TONGANOXIE PLANNING COMMISSION

PLANNING STAFF REPORT

Case#: 2020-003P –Revised Preliminary Plat / Final Plat – West Village

Re: West Village Development
Preliminary Plat, Stormwater Study, Construction Plan and Final Plat
Review
20-1001L

PREPARED FOR:
PRELIMINARY SITE PLAN
WEST VILLAGE
TONGANOXIE, KANSAS

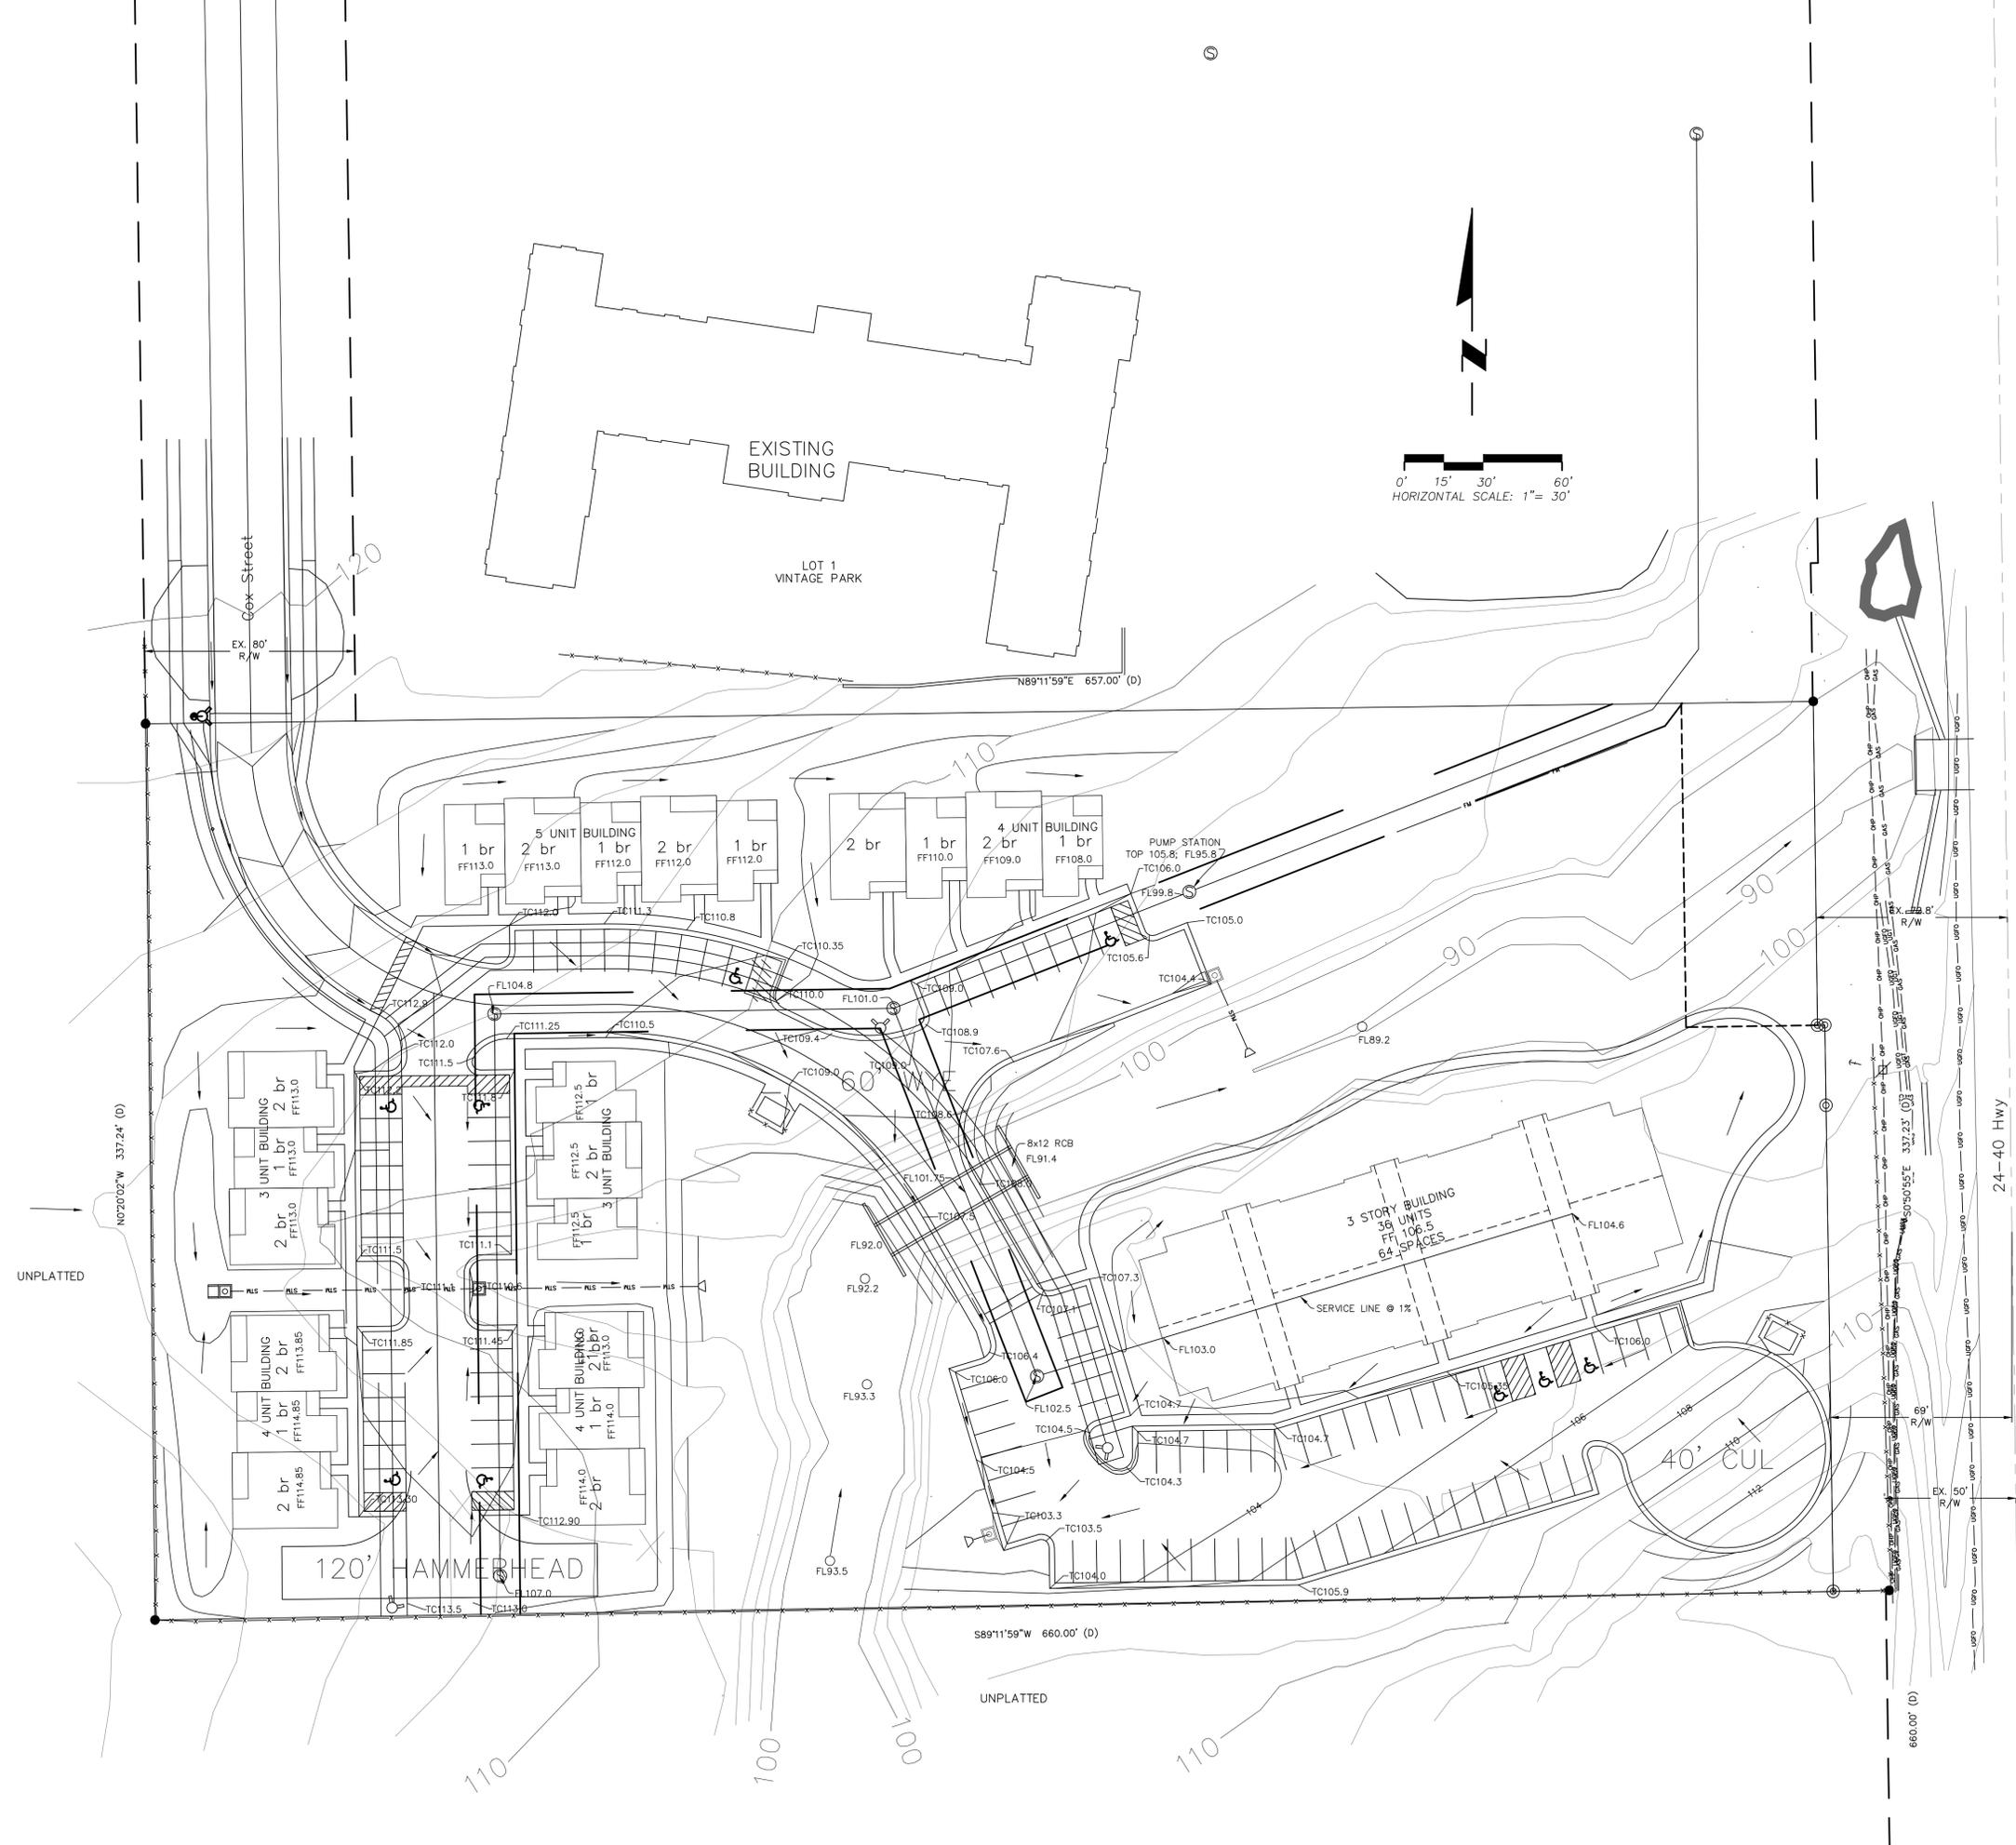
1. The private extension of Cox Street is reconfigured to be straight and to more directly stub into the property to the south. This is a change from the previously approved preliminary plat, but is consistent with the Planning Commissions requests and recommendations from the January 2, 2020 rezoning. (preserving options if changes in the area occur and Cox Street needed to connect due to future changes.)

2. The attached buildings along the Cox Street extensions have been reconfigured to more directly align with the street, and includes 14 buildings fronting the street on each side (overall the plan includes 1 additional attached unit building and 2 additional units). This is a change from the previously approved preliminary plat, but is consistent with the Planning Commissions requests and recommendations from the January 2, 2020 rezoning (creating a more defined neighborhood streetscape with the attached units), and is consistent with the R-MF-2 zoning standards. Staff will confirm that all provisions of the R-MF-2 zoning district and the approved site plan are met in this area prior to building permits.

3. The stub street to the east has been reconfigured and combined with the cul-de-sac leading to the multi-family building. In relation to this, fewer attached units are located on the stub to the east the cul-de-sac turn-around has been converted to a stub. This is a change from the previously approved preliminary plat, but is consistent with the Planning Commissions requests and recommendations from the January 2, 2020 rezoning (limiting large paved areas and stormwater run off with more efficient stubs and turn-around, provided the Fire Department approves)

4. The apartment building has been slightly reconfigured due to the above-mentioned reconfiguration of the streets and cul-de-sac extension. This is substantially similar to the approved site plan, and is consistent with the R-MF-2 zoning standards. Staff will confirm that all provisions of the R-MF-2 zoning district and the approved site plan are met in this area prior to building permits.

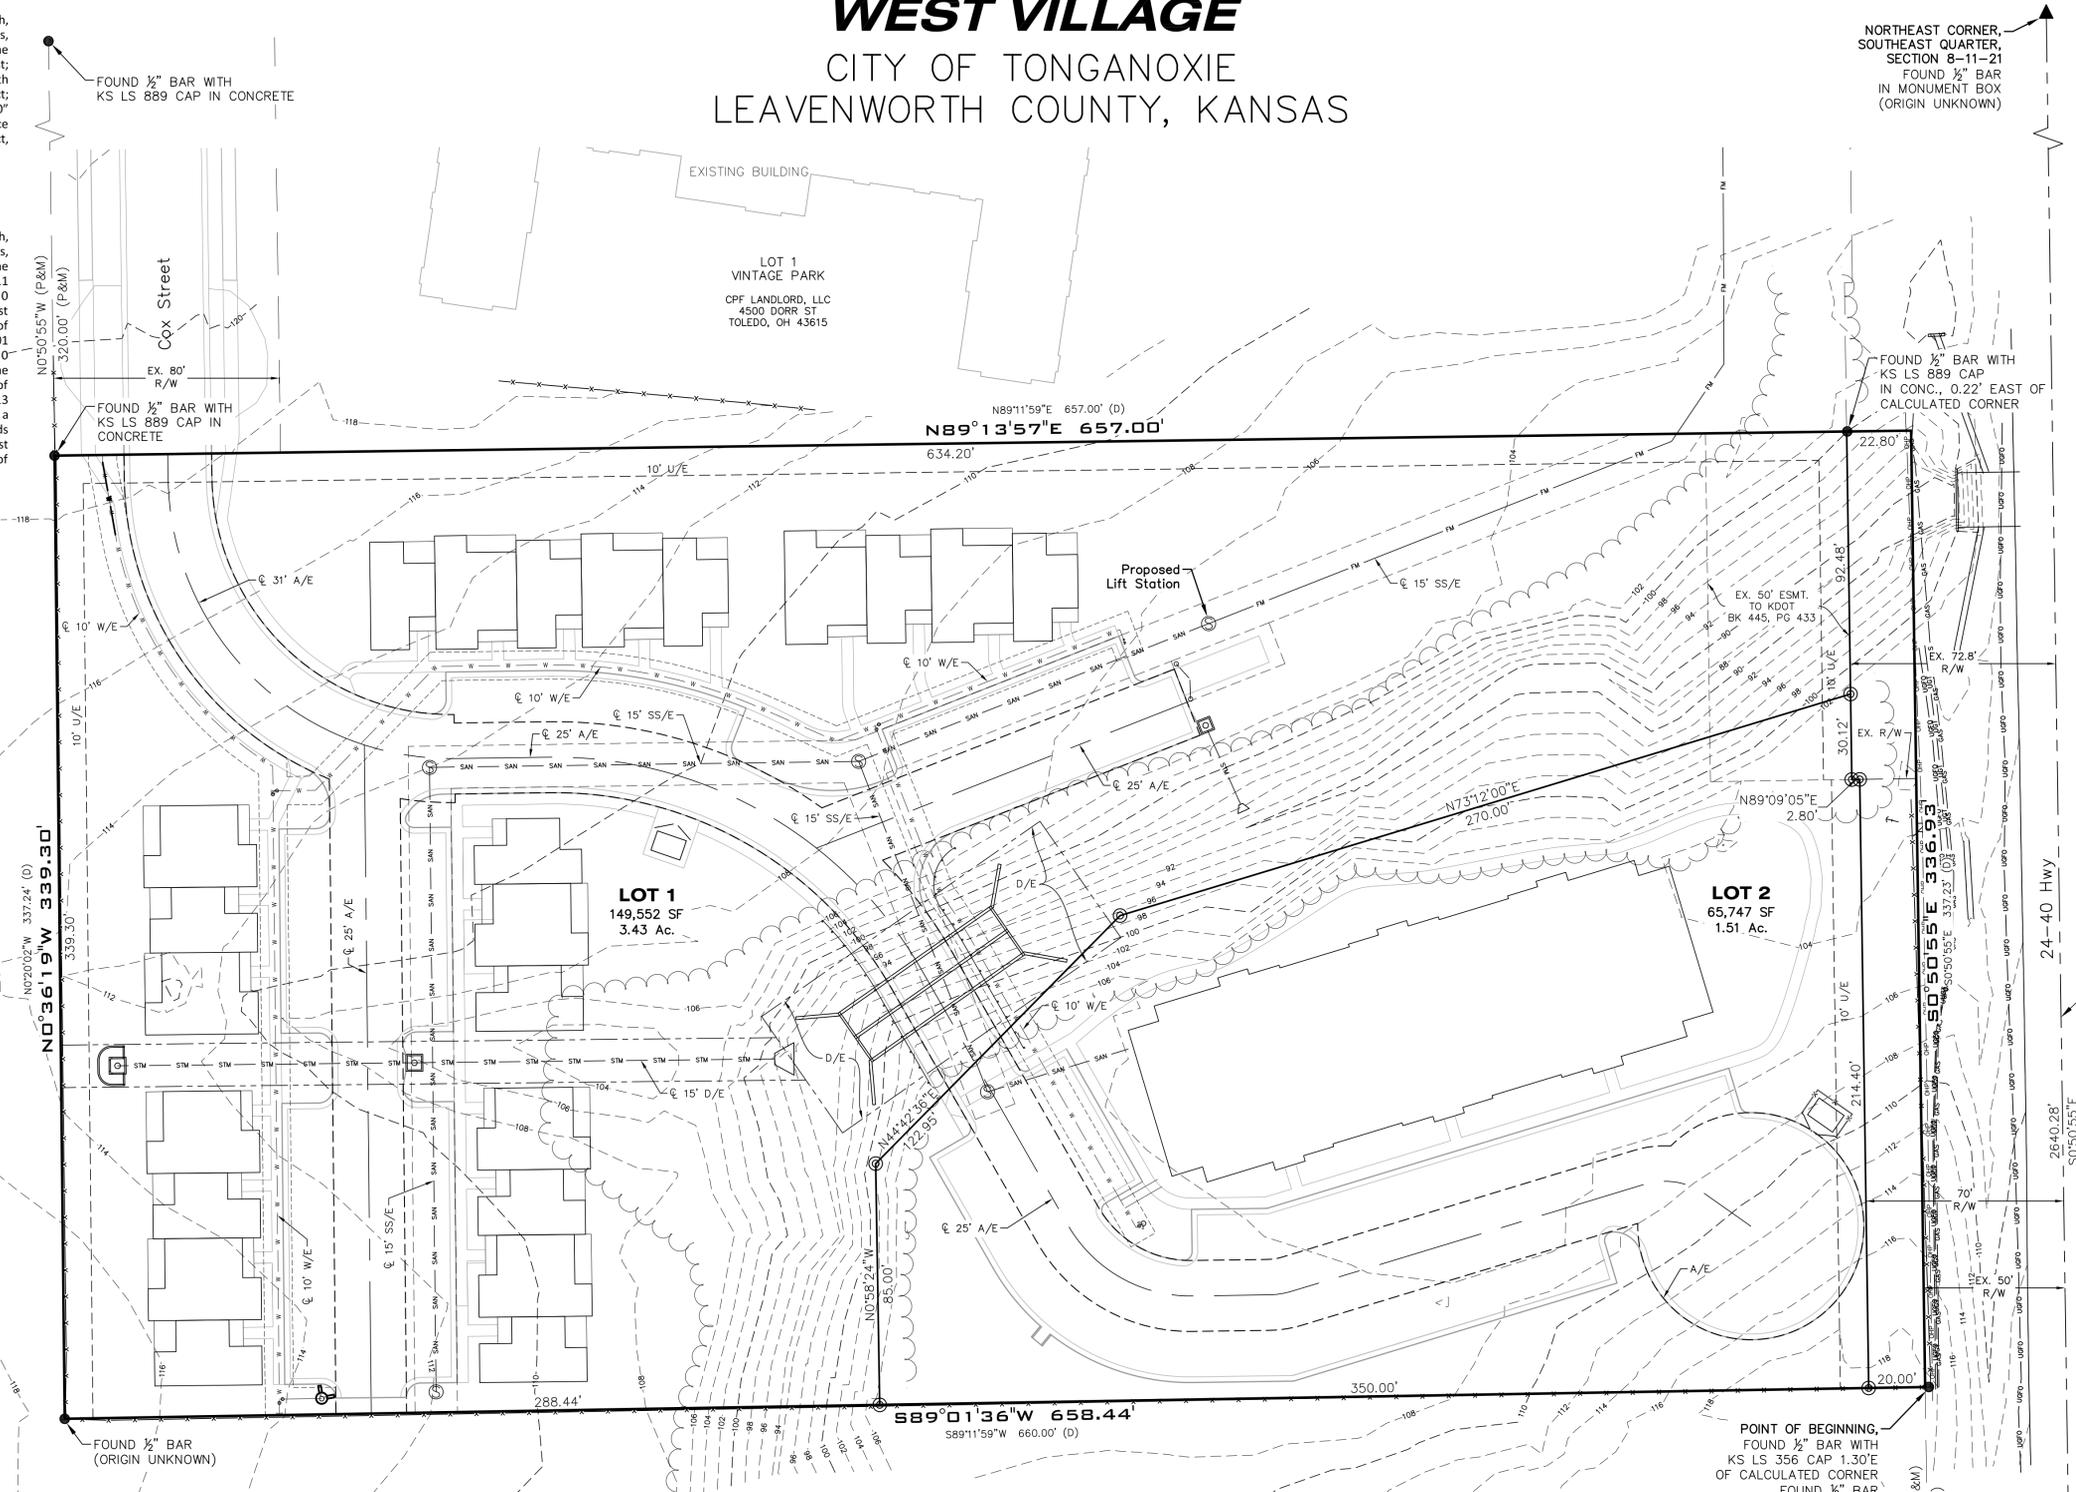
- 1) Utility easements should be provided to allow for future extension of the Sanitary Sewer and Waterline to the South and East property lines.
 - a. We recommend that a 10' wide utility easement be added along the South property line from the Southwest corner of the development to the Sanitary Sewer Manhole to the East at the end of the private drive.

Recommendation: The City should consider approval of the Final Plat dated 8-11-2020 contingent upon the above issue being addressed.
